MEMORANDUM

To: Randi Kim, Mark Ritterbush and Slade Connell - City of Grand Junction
CC: Jason Ward - Design Review Engineer
John Hunyadi - Chief, Dam Safety Branch
From: Jackie Blumberg - Dam Safety Engineer
Date: March 20, 2023
Dam Name: Juniata
DAMID: 420128
Subject: Low Level Outlet File Review

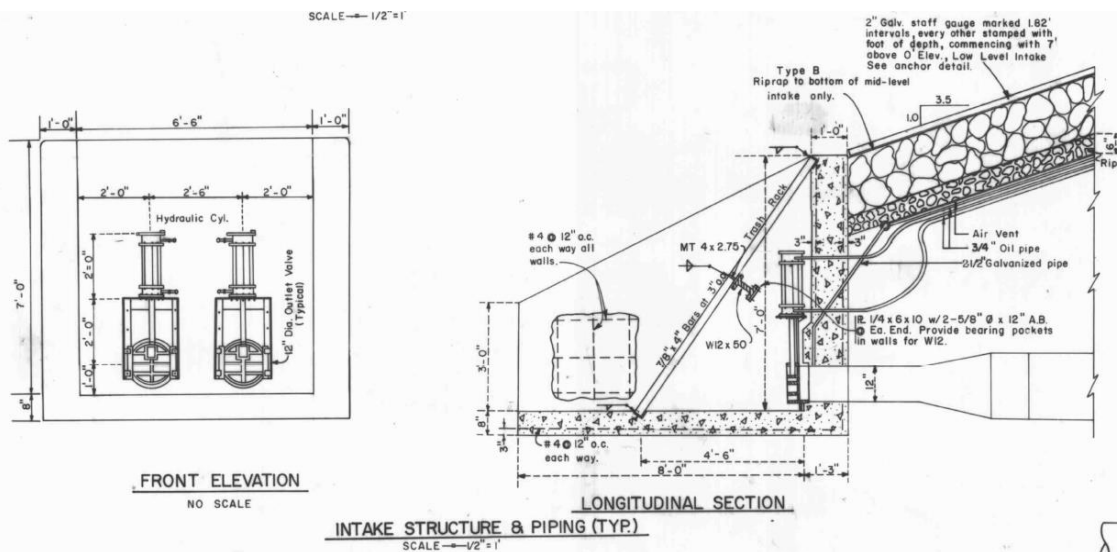
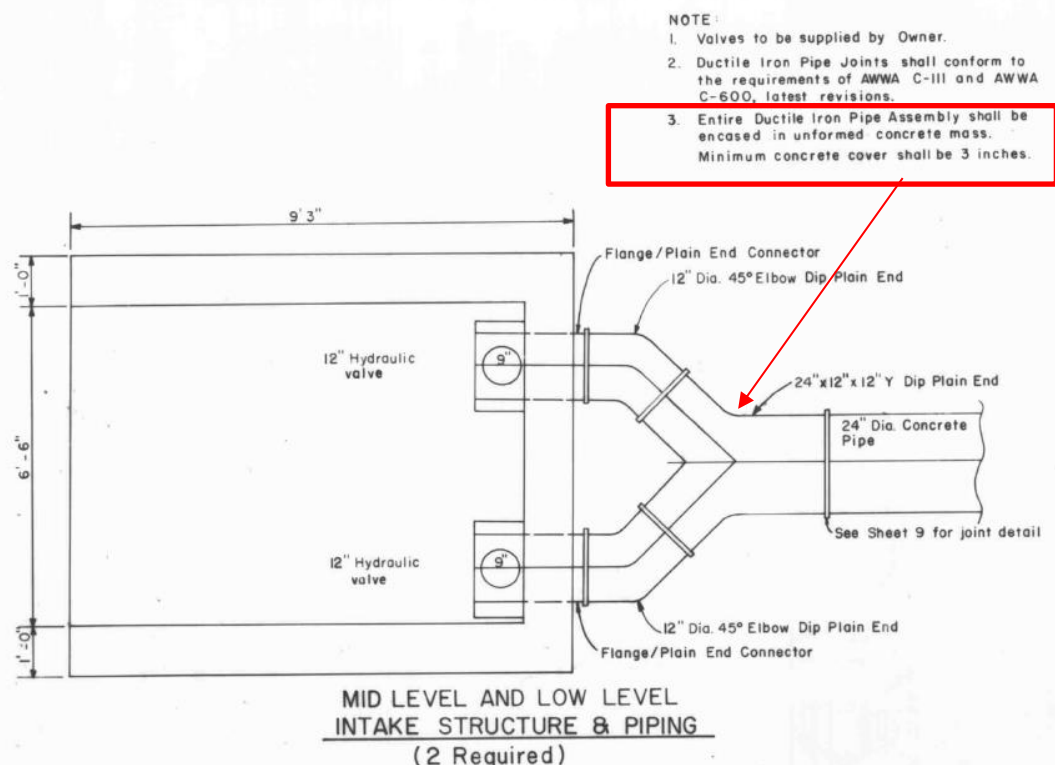
1954 intake details show air vent connection to conduit is encased by the concrete headwall.

1978 raise shows a nearly identical intake detail, one where the air vent connection to the conduit is encased by the concrete headwall. The plans show the 24-inch dia. bell and spigot RCP transitioning to 12-inch ductile iron (the original bifurcated inlet and gates). Although the detail is nearly identical, the intake structure is entirely rebuilt to accommodate the second dam raise and attendant outlet extension.

The existing CMP segment remains in place and is extended by RCP at upstream (195-feet) and downstream ends (160-feet). Notes on plans state, "Existing CMP to be excavated to first joint, cleaned, banded and extended to the limits noted with RCP". The plans also show the ductile iron bifurcated intake to be encased in unformed concrete.

LOW LEVEL GATES
← POCKET CAUSED BY DIRT IN FORMS

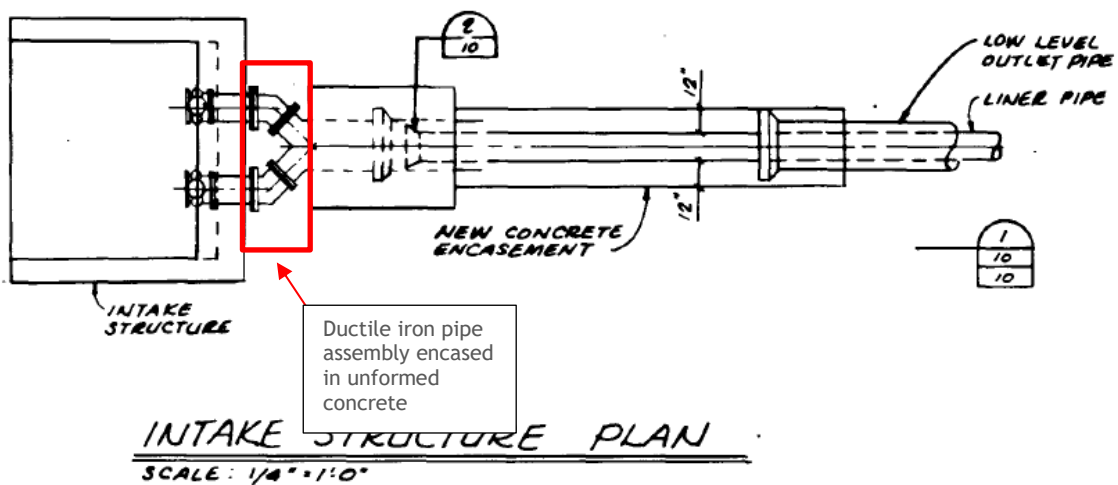
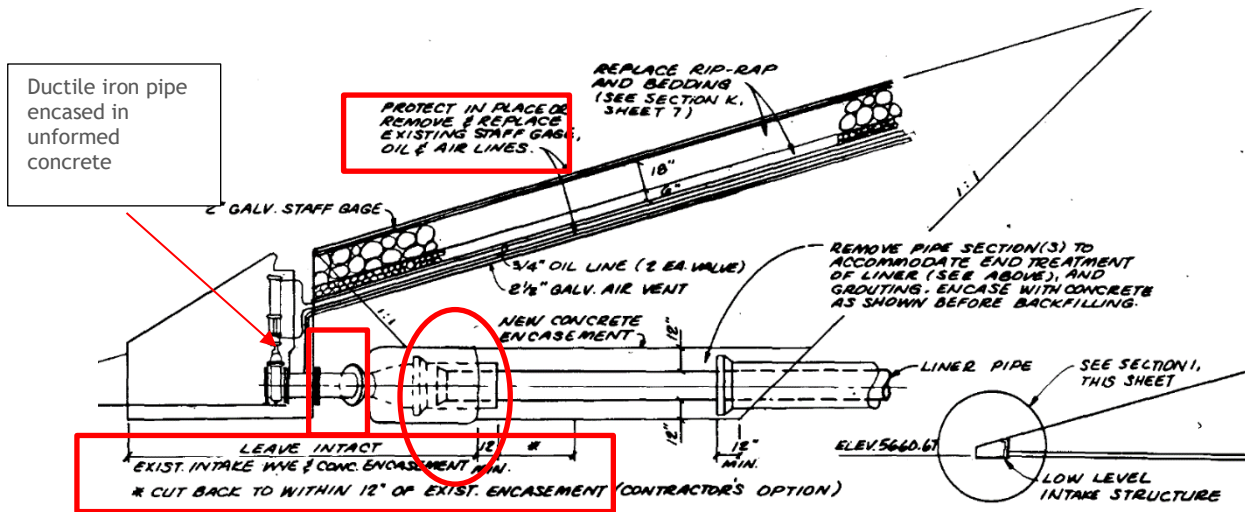
Construction inspection on April 17, 1979 revealed pockets associated with the grouted beam at the intake for both upper and lower level gates. The Contractor indicated the pocket was due to soil within the forms and not poor quality concrete.

POORLY GROUTED BEAM POCKET
ON UPPER LEVEL INTAKE.

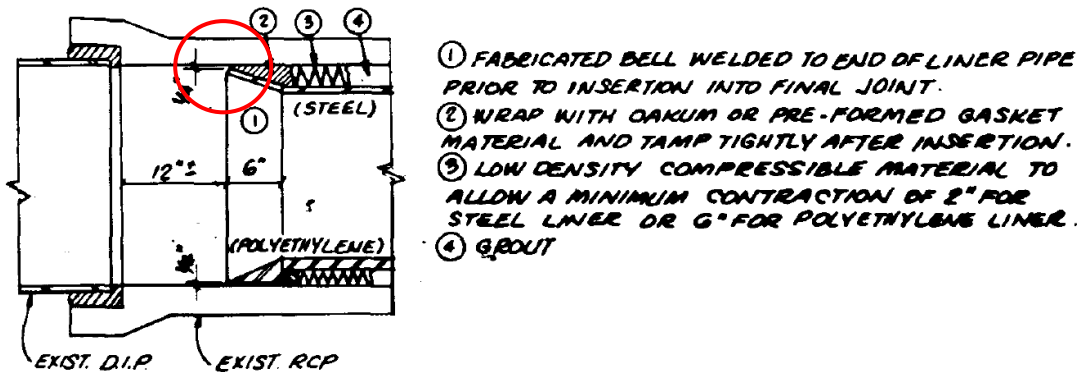
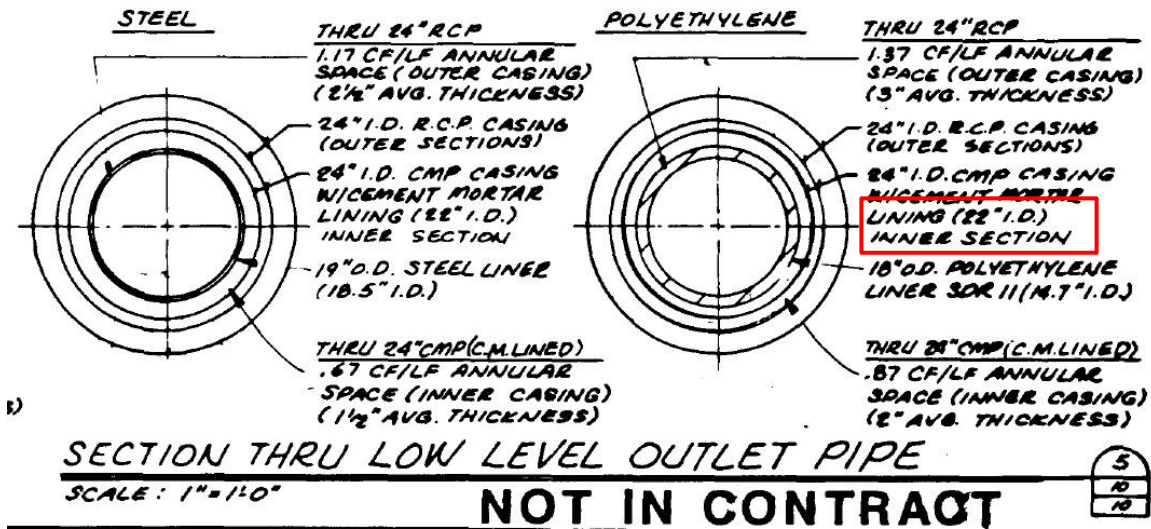
1987 details are shown below for the HDPE sliplining work. The existing concrete headwall at the intake to remain in place. Ductile iron bifurcated segment (encased in unformed concrete) also to remain in place. Refer to end of this memorandum for 1986 video inspection discussion that prompted the work. Structural calculations showing load resistance were provided.

Below shows the section view for pipe lining. Ultimately, HDPE was selected as the liner pipe that would be pulled through the host pipe and the annular space grouted. Based on construction drawings,

the segment through the longitudinal center of the dam would be comprised of (extending outward from center): HDPE (14.7-inch ID/18-inch OD), grout, cement mortar (22-inch ID), CMP (24-inch) with asbestos coating (assuming host pipe is intact). The extended end segments would be: HDPE (18-inch ID), grout, RCP (24-inch), discrete concrete encasement at ends (appears as 48-inch OD on plans, assuming host pipe is intact).
